MEMORANDUM

TO: Planning, Housing, and Economic Development (PHED) Committee  
FROM: Marlene Michaelson, <sup>MM</sup> Senior Legislative Analyst  
SUBJECT: Westbard Sector Plan

This is the Planning, Housing, and Economic Development (PHED) Committee's third worksession on the Westbard Sector Plan. This worksession will continue the Committee's discussion on specific properties and other issues not addressed at the first worksession. While most of the memorandum has not changed from the memorandum for the March 7 worksession, Staff has clarified certain recommendations and changed the zoning recommendation on a portion of the Washington Episcopal site and added a new section on public amenities. New text has been underlined. Attached on © 1 is a map of all specific properties. Attached on © 2-5 is a memorandum from Councilmember Berliner relating his thoughts on the Plan.

Figure D.7: Westbard Parks Recommendations Initial Phase Area Map

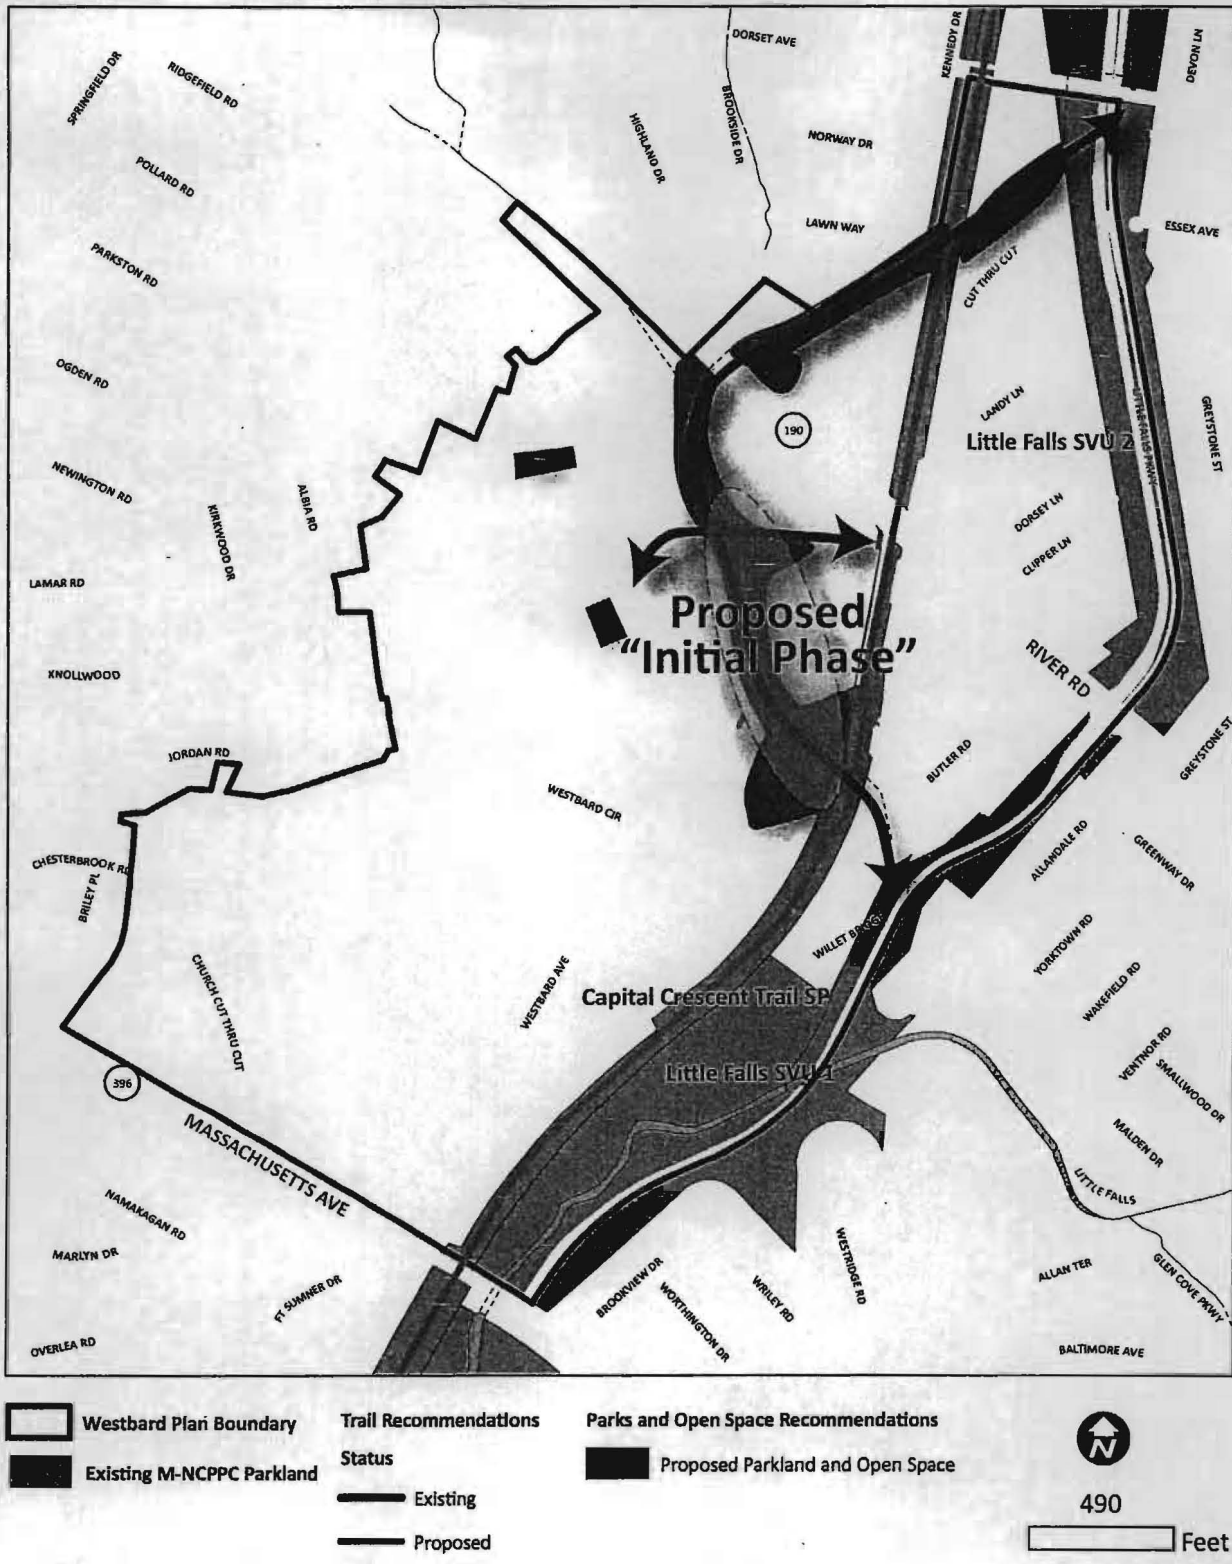
The portion of the project that Staff believes should constitute Phase 1 is shown as the "Proposed Initial Phase" on a map on page 101 of the Sector Plan Appendix and attached on © 6. Phase 2 would include portions of the park associated with development that is likely to occur in the relatively near term (area C on the map on page 107 of the Sector Plan Appendix and attached on © 7). The portion Staff has identified as Phase 3 includes those portions of the park associated with **longer-term** development likely to occur beyond the time horizon of this Plan (e.g., daylighting of portions of the stream on the Washington Episcopal School (WES) property.) These areas are shown as areas A, B, and D on the map on © 7. County funding for acquisition and development could be considered at a later date if these properties do not redevelop.

**Staff recommends that the Council ask the Planning Board to prepare a more detailed phasing plan, identifying which portions of the Greenway can be expedited with public funding. Staff further recommends that the PHED Committee schedule a meeting this summer to discuss M-NCPPC priorities for acquisition and where acquisition of portions of the Willett Branch Greenway fit within the list of priorities. Staff believes that plans should be made to acquire necessary parcels as soon as possible, but that determination cannot be made without considering whether it would divert money from other equally or more important acquisitions. Facility planning should be scheduled immediately following acquisition.**
